RS-08-117

Braidwood Station, Units 1 and 2
Facility Operating License Nos. NPF-72 and NPF-77
NRC Docket Nos. STN 50-456 and STN 50-457

Byron Station, Units 1 and 2
Facility Operating License Nos. NPF-37 and NPF-66
NRC Docket Nos. STN 50-454 and STN 50-455

Subject: License Amendment Request to Adopt TSTF-490 Deletion of E Bar Definition and Revision to RCS Specific Activity Technical Specification

Figure 3.4.16-1 (page 1 of 1)
Reactor Coolant DOSE EQUIVALENT I-131 Specific Activity
Limit Versus Percent of RATED THERMAL POWER

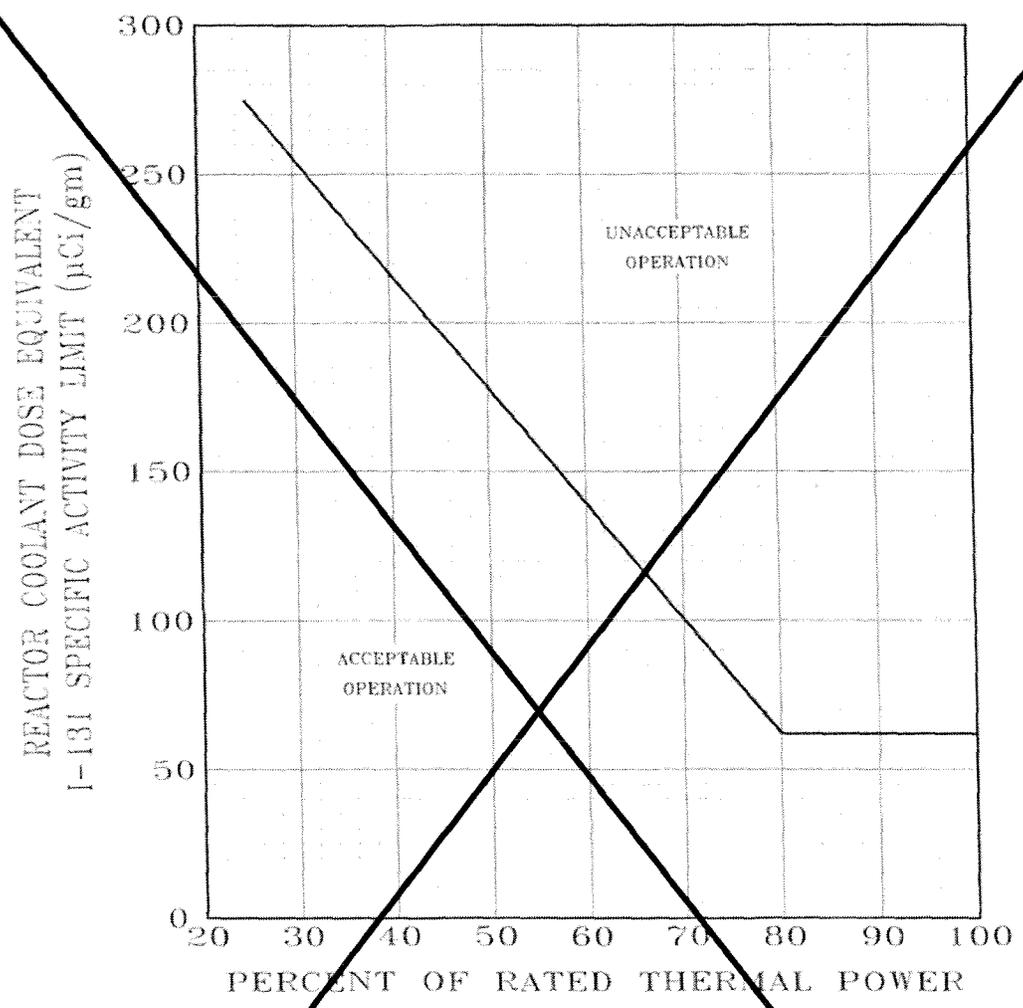
4. Revise LCO 3.4.16, "RCS Specific Activity," to delete references to gross specific activity; add limits for DOSE EQUIVALENT I-131 and DOSE EQUIVALENT Xe-133; and delete Figure 3.4.16-1, "Reactor Coolant DOSE EQUIVALENT I-131 Specific Activity Limit versus Percent of RATED THERMAL POWER."

5. Revise LCO 3.4.16 "APPLICABILITY" to specify the LCO is applicable in MODES 1, 2, 3, and 4.
6. Modify ACTIONS Table as follows:
 - A. Condition A is modified to delete the reference to Figure 3.4.16-1, and define an upper limit that is applicable at all power levels.

C. Required Action and associated Completion Time of Condition A or B not met. <u>OR</u> DOSE EQUIVALENT I-131 > 60 $\mu\text{Ci/gm}$.	C.1 Be in MODE 3. <u>AND</u> C.2 Be in MODE 5.	6 hours 36 hours
-------------------------------------------------------------------------------------------------------------------------------------------------------------------	--------------------------------------------------------------	---------------------------------
